March 7, 2024

Re: Hamilton-Wenham Regional High School Athletic Campus Redevelopment
Outstanding Permit Items for the Planning Board
Gale JN 718601

On behalf of the Hamilton-Wenham Regional School District (HWRSD), Gale Associates, Inc. (Gale) is submitting this letter in response to the discussions at the February 28, 2024, planning board meeting and the Boards remaining items. Below you will find the remaining items noted in **bold** font and Gale's responses in plain text.

1 GROUND LEVEL FLOOR PLAN
SCALE: 1/4" = 1'-0"

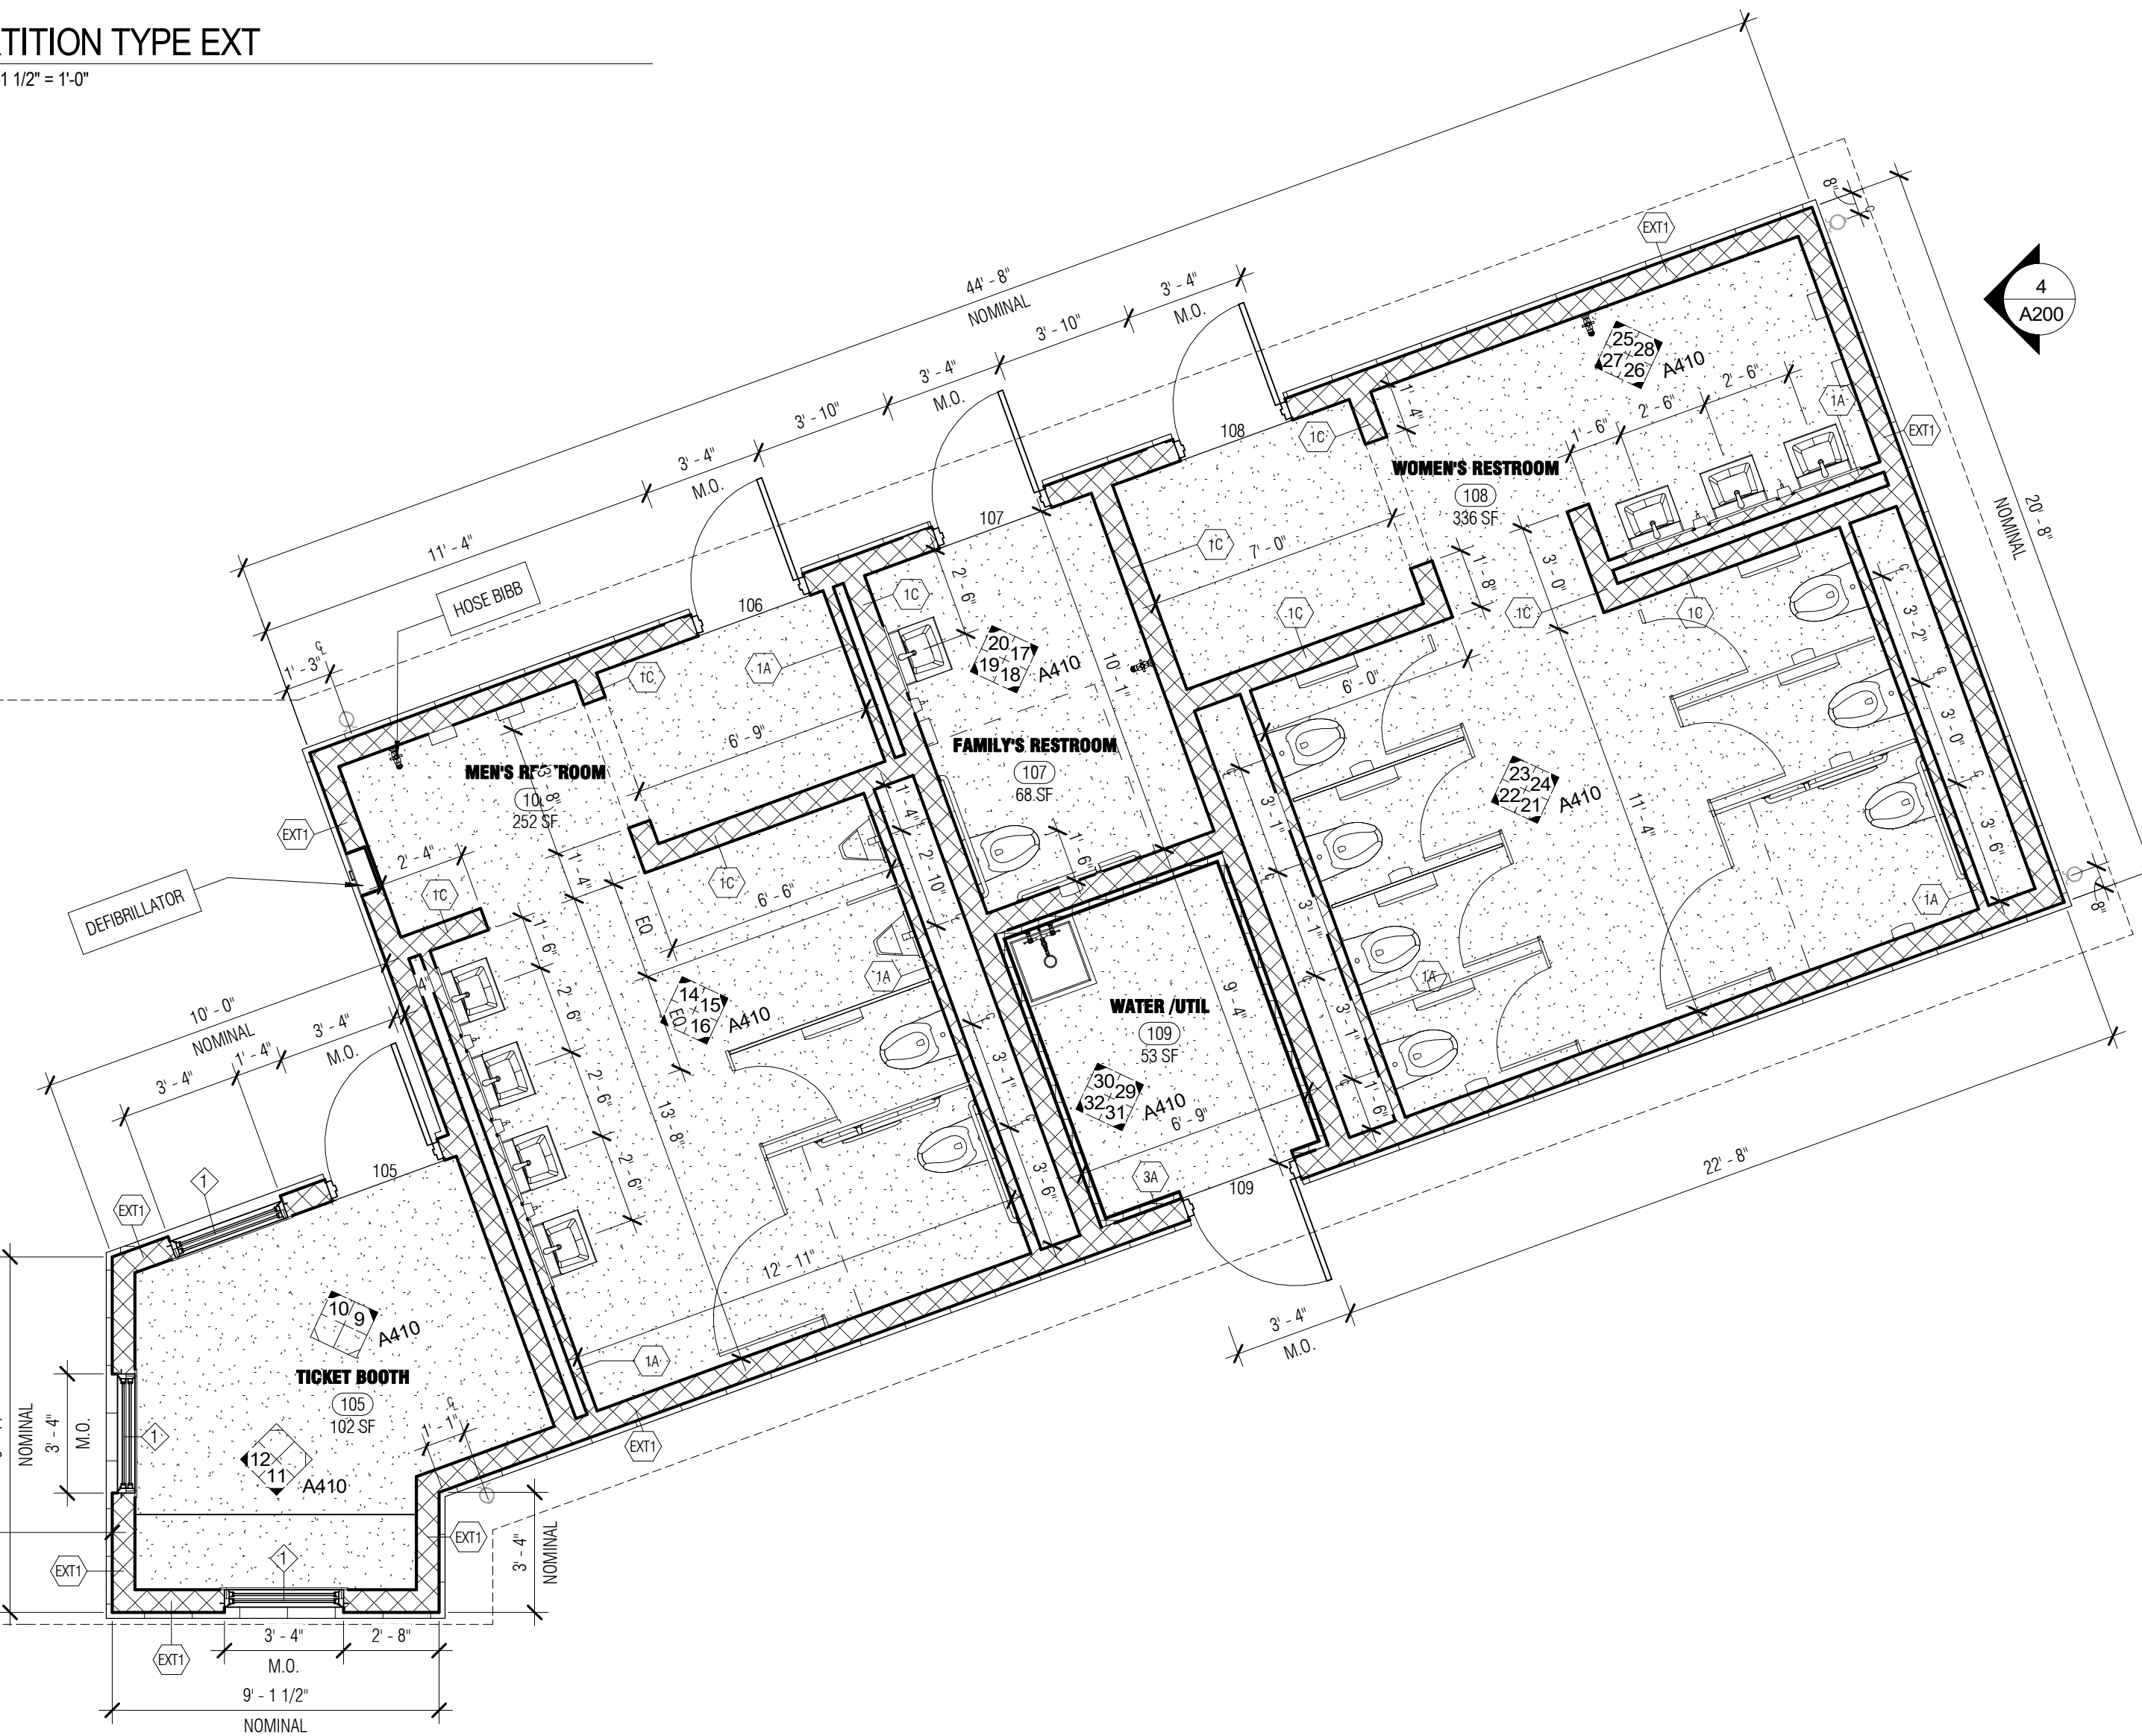
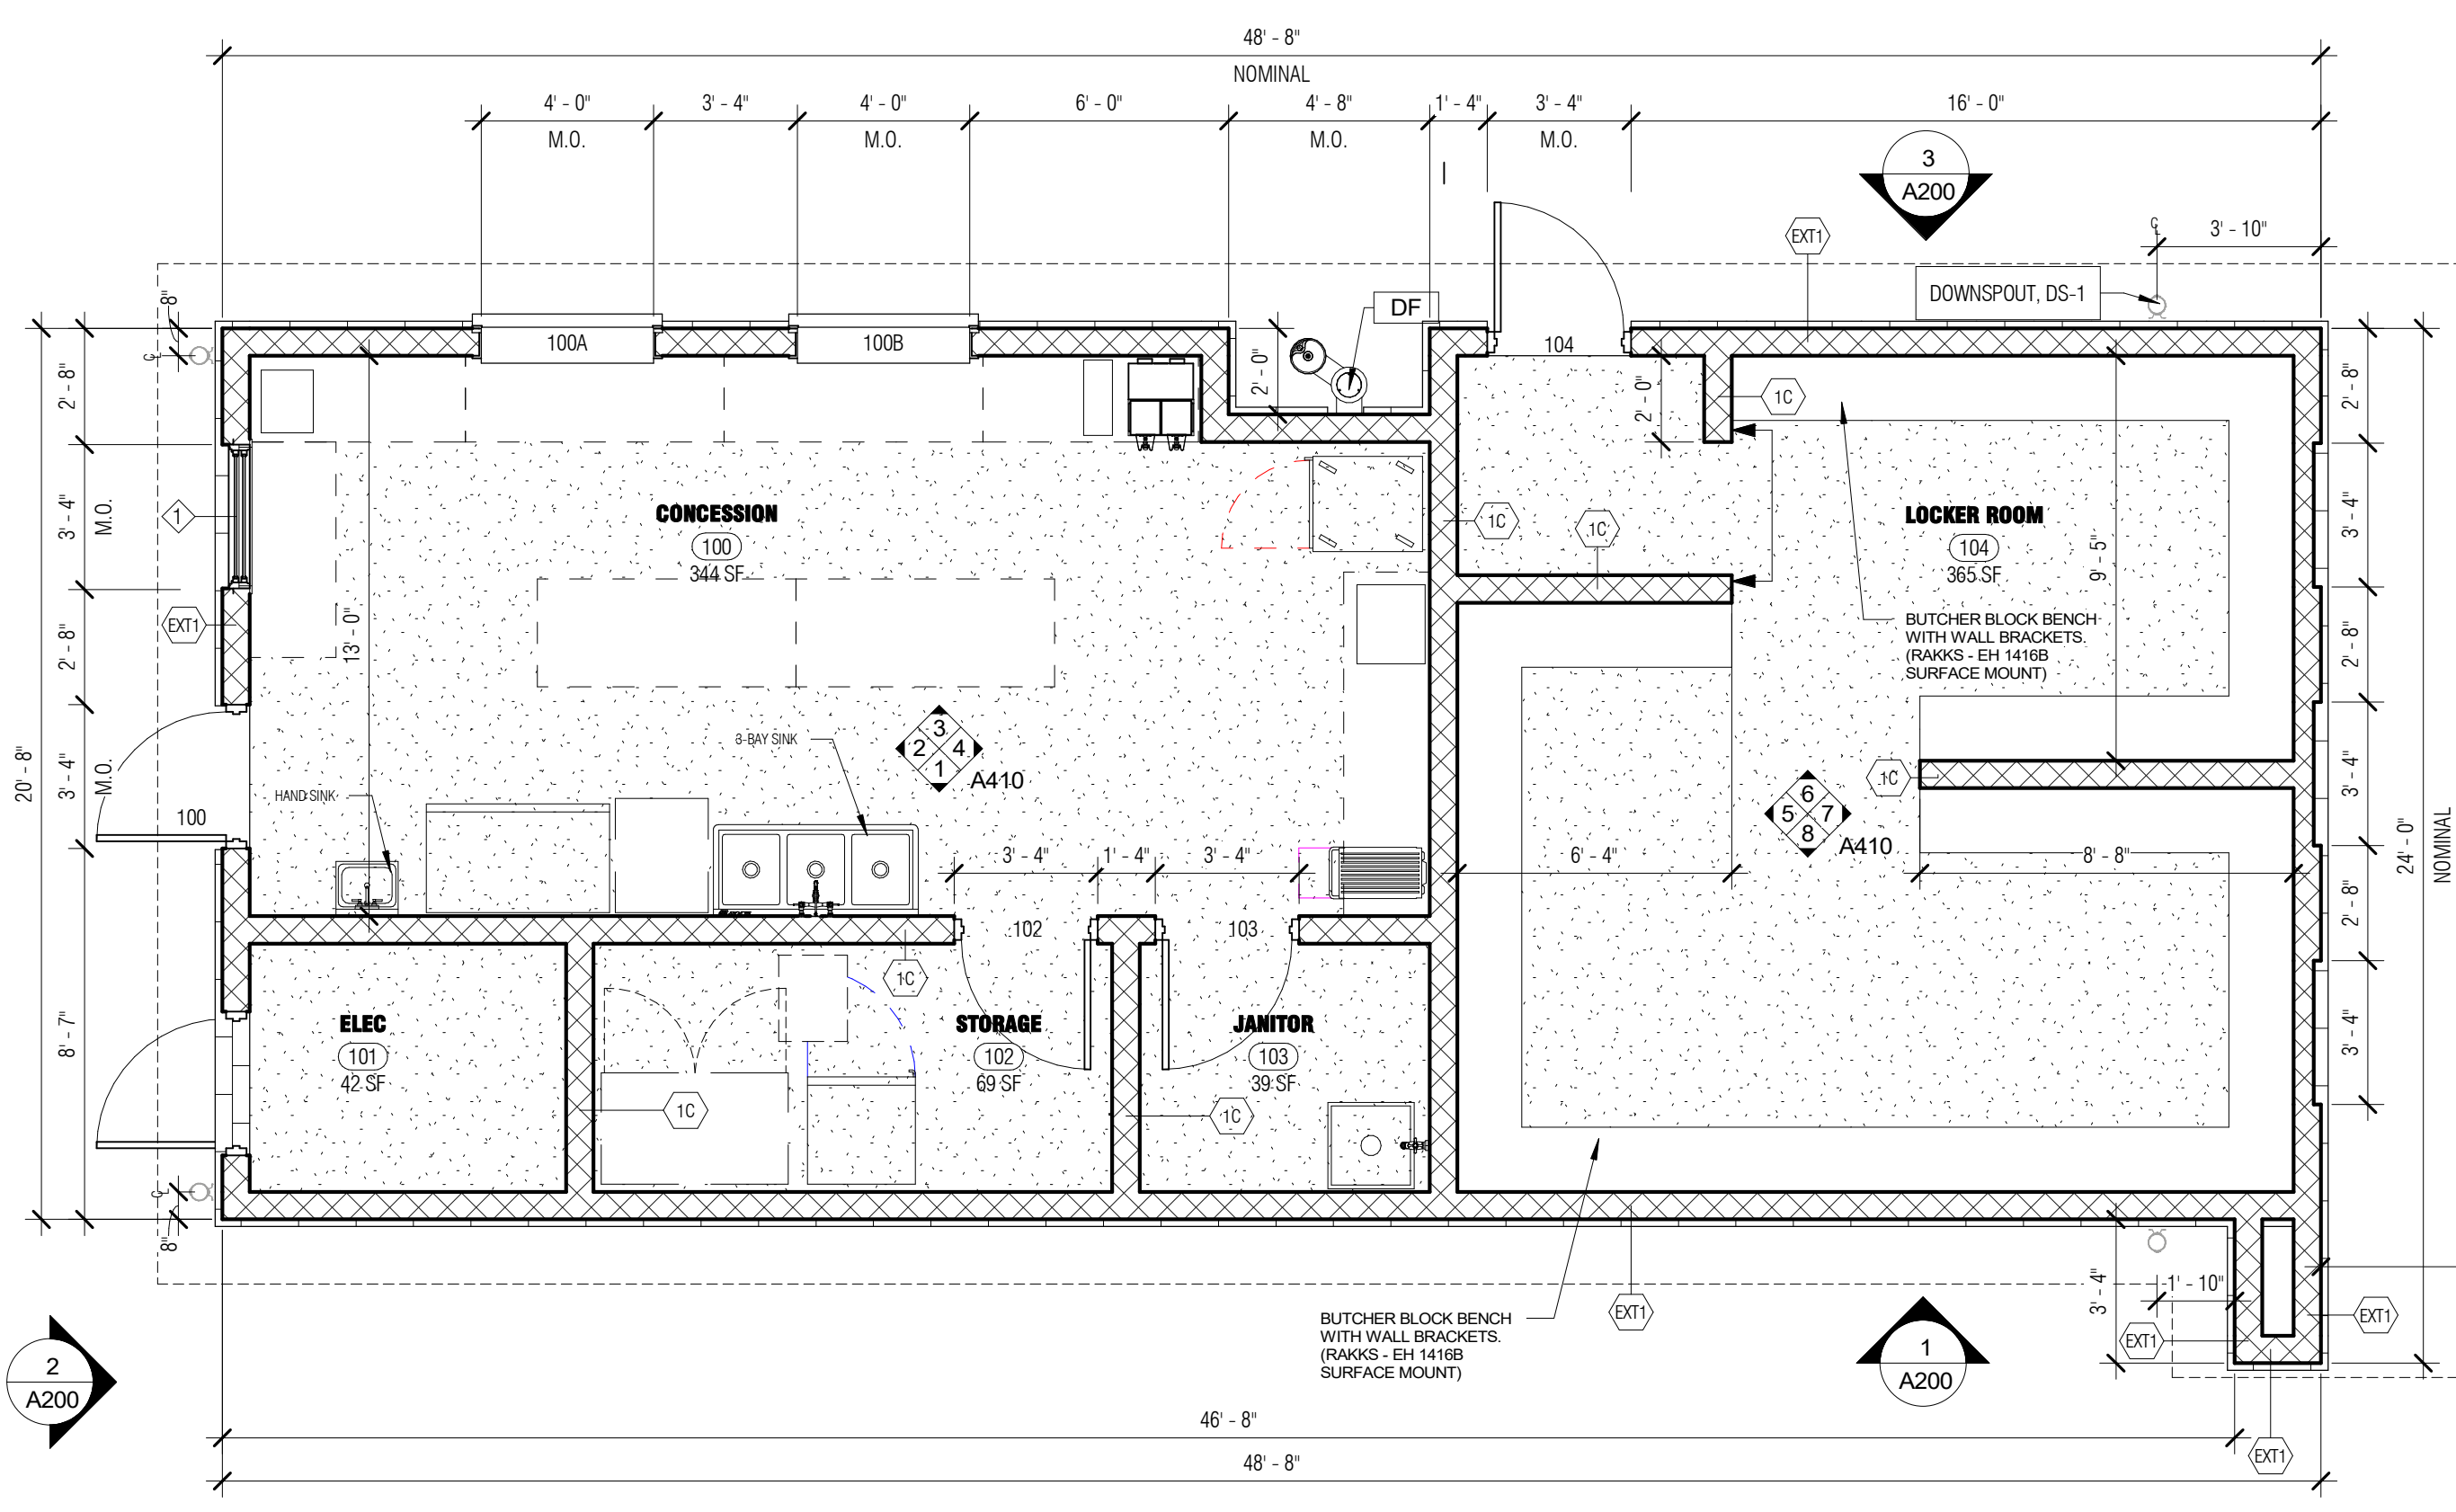
4. Amenities Building design is still in process

Response: Gale provided the building layout and utility connections with our last submittal which were approved by the Peer Reviewer; however, we have attached the Amenities Building Plans again for your reference.

ILLUMINATION SUMMARY

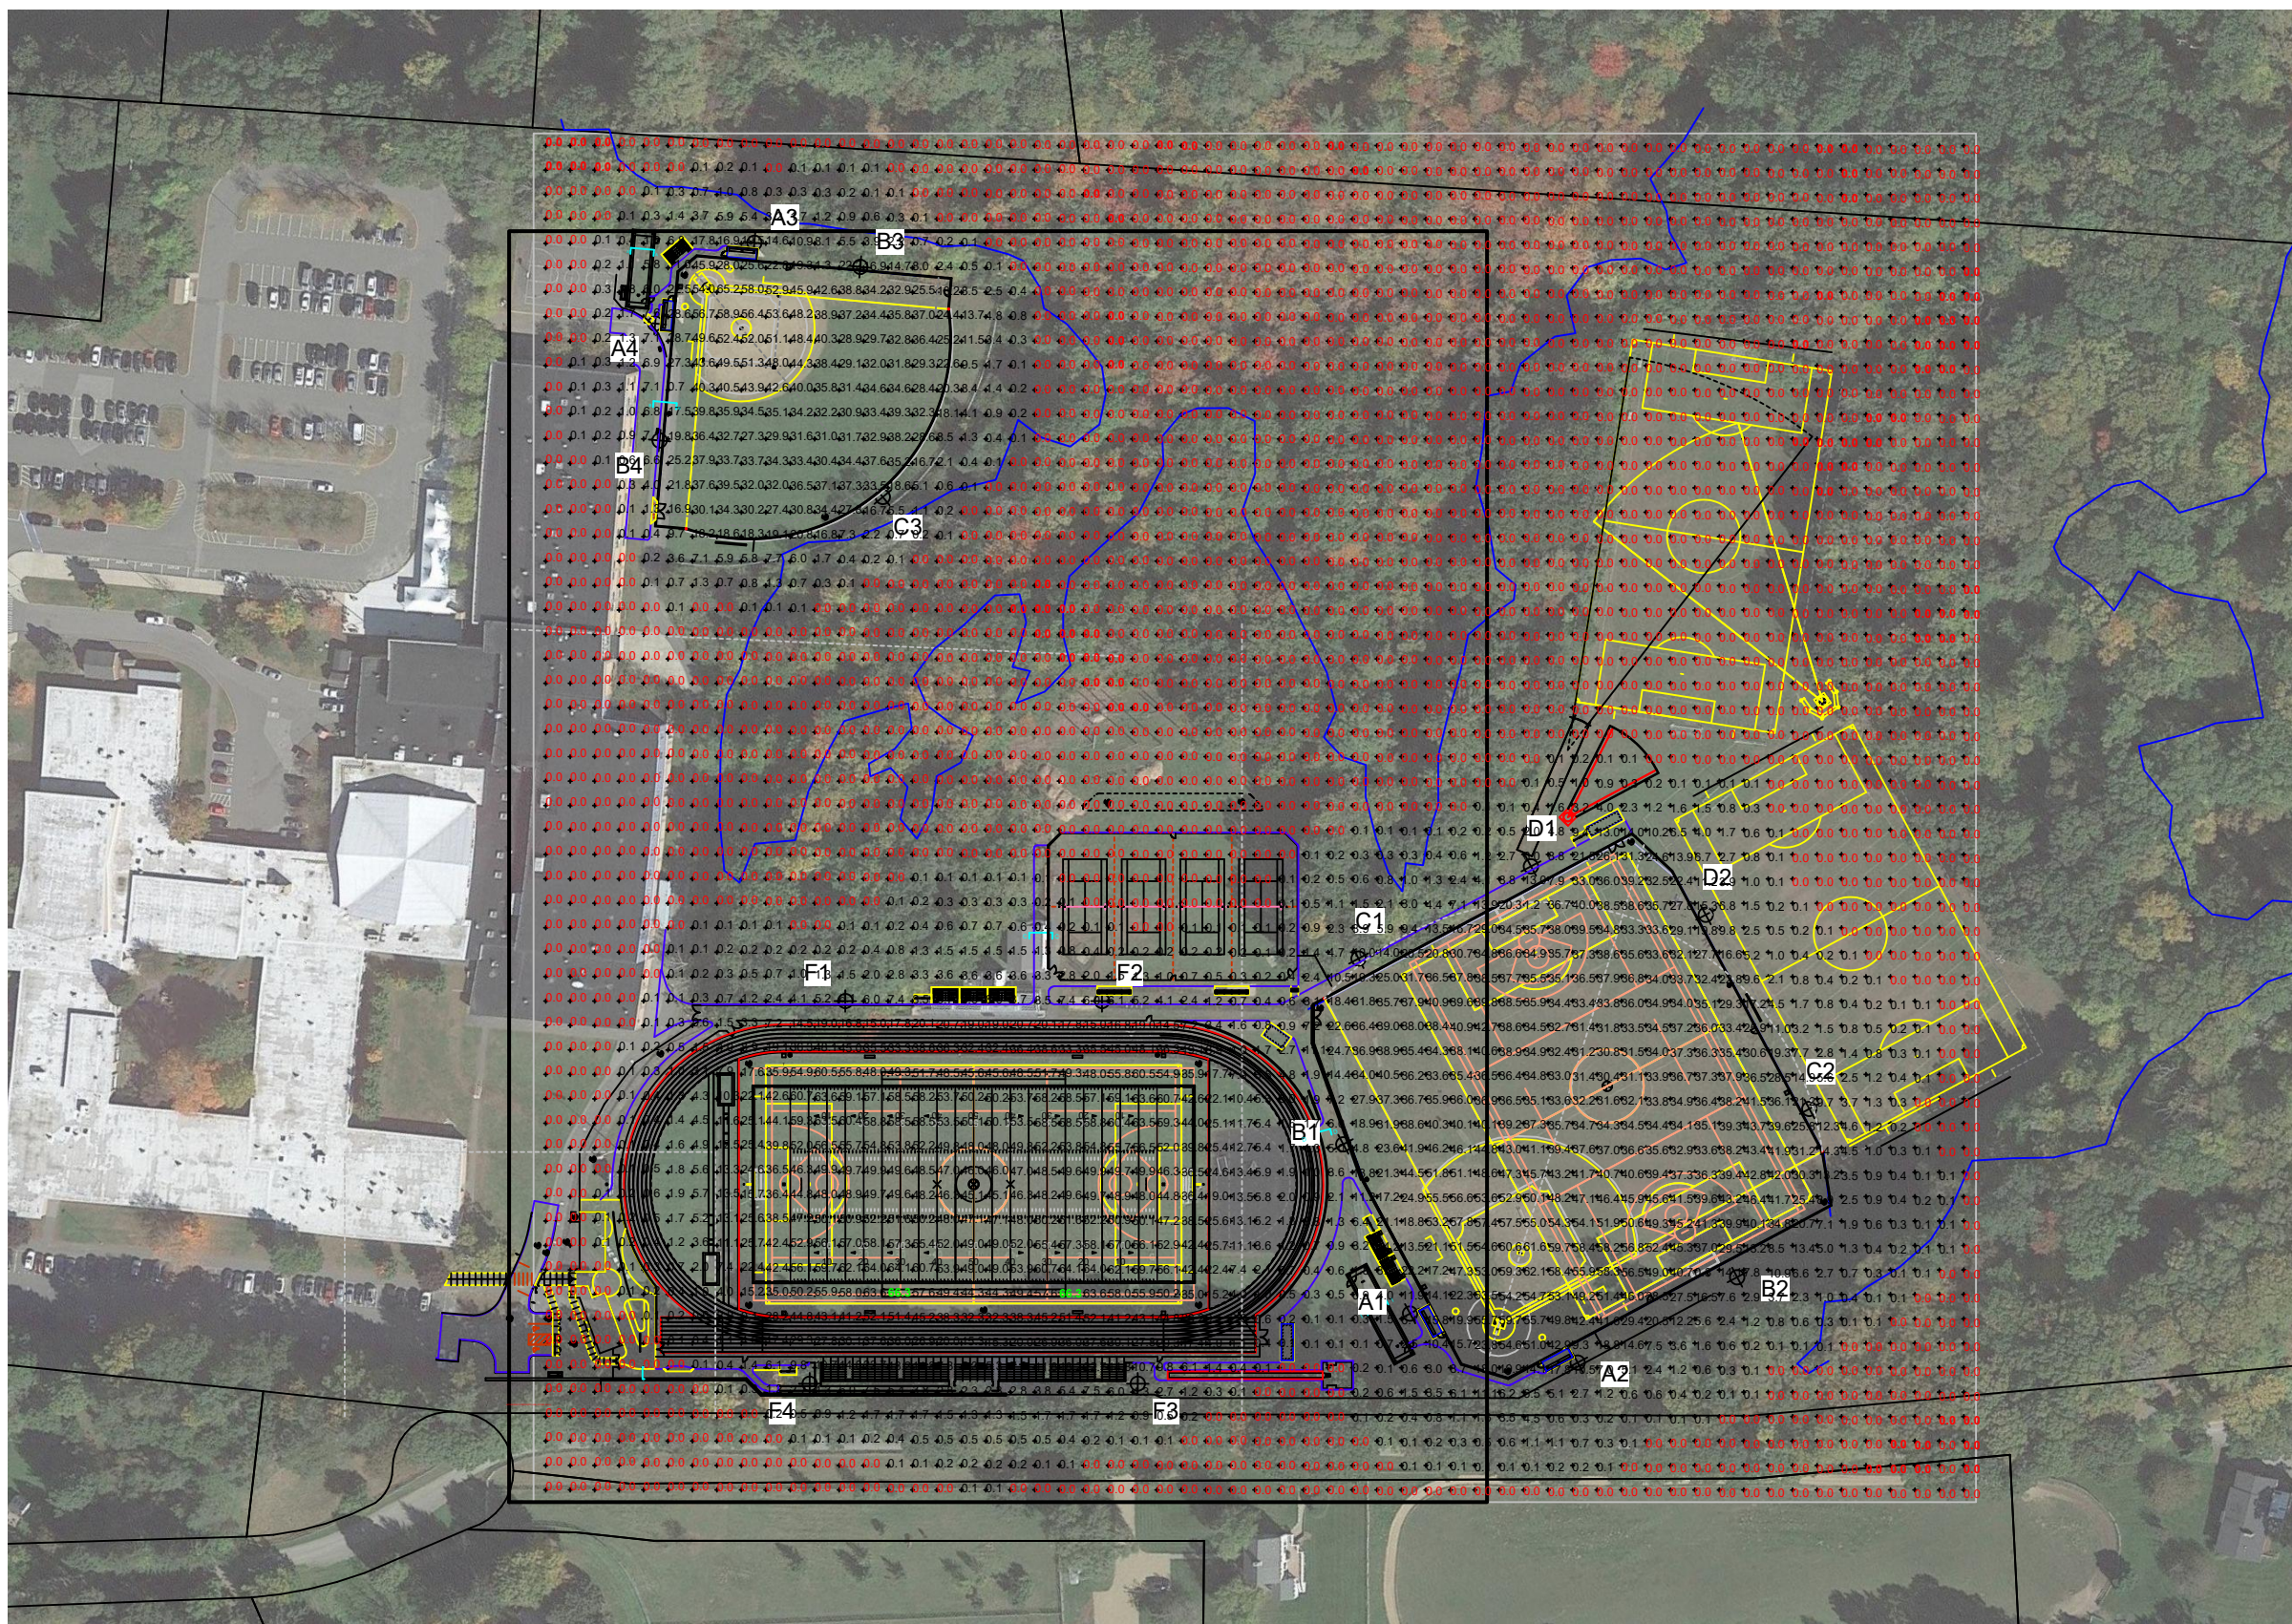
9. Illumination plan with property lines & wetland boundary

Response: Attached is a copy of the updated Illumination Plan with property lines and wetland boundaries added as requested.
